Re: Verizon Permit Application for Small Cell Installation

110 Howland Avenue (Parcel ID #6054-14-34746460-3-14.1)

City of Beacon, New York, 12508 Verizon Site Name: Howland Micro

Technical Review Memo

Cross-section view of proposed 110 Howland Avenue wireless telecommunications facility

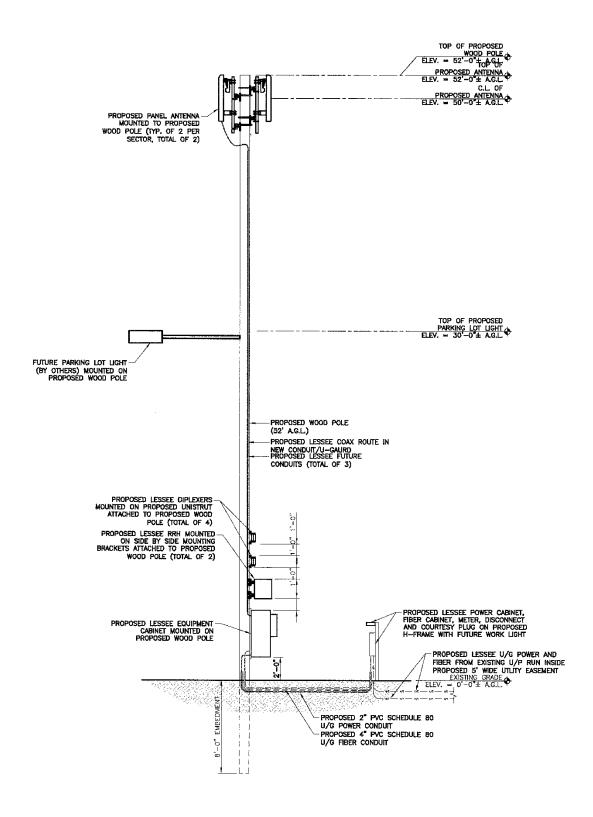
- The proposed antennas, mounting structures and cable runs shall be color matched to the pole and in accordance with the photosimulations provided for this application. A matte finish is recommended for all proposed equipment. For the ground-based equipment fencing, a white color and texture to match the existing fencing at the site (see above photos) is recommended. The height of the fencing (all 4 sides) shall be consistent with the existing fencing off the parking lot, and HDR recommends it be no shorter than the height of the RRH units depicted on the cross-section Drawing (approx. 7 8 ft). The proposed fencing shall comply with Section 223-13.G, unless the Building Inspector determines that this Section does not apply and a taller fence is permitted around the small cell pole and equipment. If approved, the height of the small cell fencing would be greater than the adjacent existing fencing (approx. 5 ft), but the additional height (and signage) would serve to deter trespassing.

- If the Special Permit is approved, a structural and foundation analysis shall be provided as part of the future Building Permit application. It is understood that no guy-wires or exterior supports are proposed. The analysis should also account for a possible parking lot lighting fixture (depicted on the Drawings). Any lighting proposed or planned shall first be approved by the City Building Department. No lighting is proposed or required as part of Verizon's small cell application.

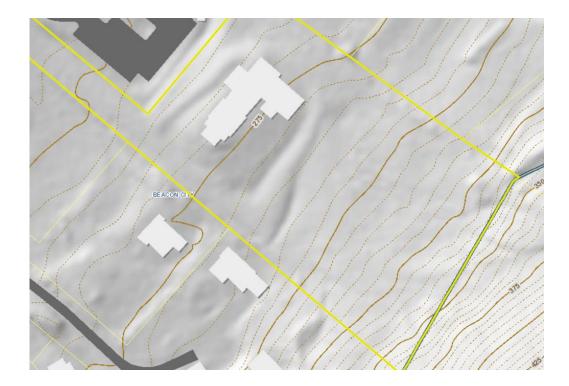
- At the 2/26/2019 meeting, the option to move the proposed small cell facility towards Mount Beacon (further back from the parking area; eastward / southeastward) was discussed. In addition to logistical constraints, the RF Engineer provided a verbal description of signal impedance that would result if the facility were located further back / into the denser tree line. A brief written narrative to this point from the RF Engineer is requested. PROVIDED - The applicant has noted that location of the small cell facility east / southeast is not a viable option from an RF perspective due to 'shadowing' from the northern tree lines and lack of an existing access road. The applicant has also stated that small cell facilities, as opposed to macro cell tower sites, typically are not designed to include construction and maintenance of access roads. Per the applicant: The possibility of moving the facility back further on the property was considered by Verizon Wireless during the initial design of this site. The site's relocation was denied by construction due to the lack of access associated with relocating the facility further back on the property. Verizon Wireless policy concerning small wireless facility deployment prohibits construction of access roads as part of its small cell program. In addition to construction concerns, there are also radiofrequency concerns with relocating the facility further back on the property relative to the existing tree lines. Specifically the northern tree line which would create additional "shadowing" degrading the capability of the site to unacceptable levels. Lack of an access road would also create significant issues relative to maintenance of the facility.

There appears to be approximately 100 ft or more of grassed area where the tower could possibly move back (southeast) towards the base of the mountain. However, the ground elevation would increase by as much as 20 ft, which would likely, in turn, increase the visibility and appearance of height from Route 9D and neighboring properties to the south. The below image demonstrates the rise in topography from approximately 275 ft amsl (where the small cell is currently proposed) to the end of the property line (in yellow). See below discussion under Section 5.

- The Drawing set (e.g., DWG Z-1) should be updated to show all property lines for the subject site, including the back property line. PROVIDED property lines were added. HDR's site visit noted a drainage swale on the slope behind the parking area with a sign marked "Private Property". It is requested that Verizon confirm if any subgrade utilities or easements may be associated with this feature. Information on subgrade utilities not provided. The updated drawings provided by the applicant depict a 5 ft wide utility easement, which is for an underground power and fiber run to an existing utility pole, located about 250 ft away. Photos of the area behind the proposed compound, including the drainage swale, are included earlier in this Tech Memo.

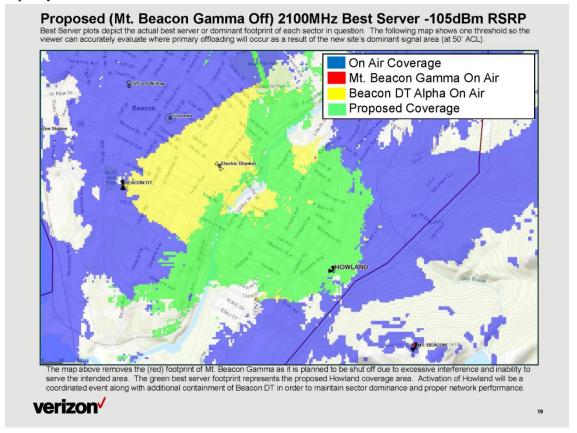
The below map (2100 MHz) provides a similar area scale, and includes signal modeling for the proposed small cell. The green area below indicates coverage and capacity for the 'open space' signal, which can be compared with the orange color in the above map. New and supplemental service has adequately been depicted. The application materials also include capacity trends from the existing macro cell sites Beacon DT

and Mt. Beacon, which demonstrate that the sectors facing towards the 110 Howland Avenue area are at capacity limits.

Coverage Map. Green depicts the proposed Howland site coverage (2100 MHz, as presented above); Red depicts that of a facility located at the Beacon Water Tank.

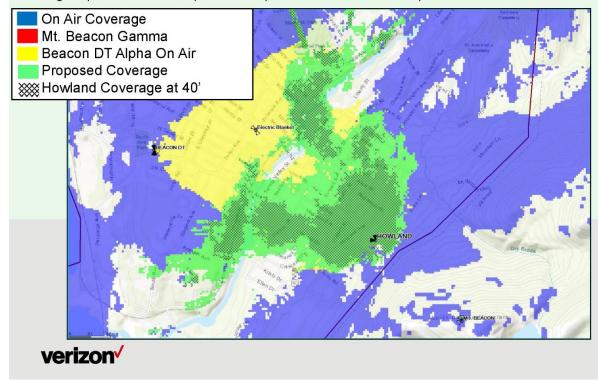
At the City of Beacon's request, the applicant completed an analysis of locating a new wireless small cell facility at the existing <u>City of Beacon water tank</u>, located off Howland Avenue, near the Breakneck Ridge Trail. The January 22, 2019 analysis concludes that the water tank is located too far away (800 ft) from the target area, and the height/elevation afforded is too low to meet the required coverage objectives. An image that depicts the coverage from the water tank and the proposed 110 Howland Avenue site is provided below.

HDR also notes that the water tank appears to be on a parcel that is listed on the National/State Register of historic places (Mount Beacon Incline Railroad). The hiking trail starting at the parking area at the Route 9D / Howland Avenue corner leads to a trail and observation area at the base of the incline, from which a facility at the water tank may be more visible than the proposed site at 110 Howland Avenue.
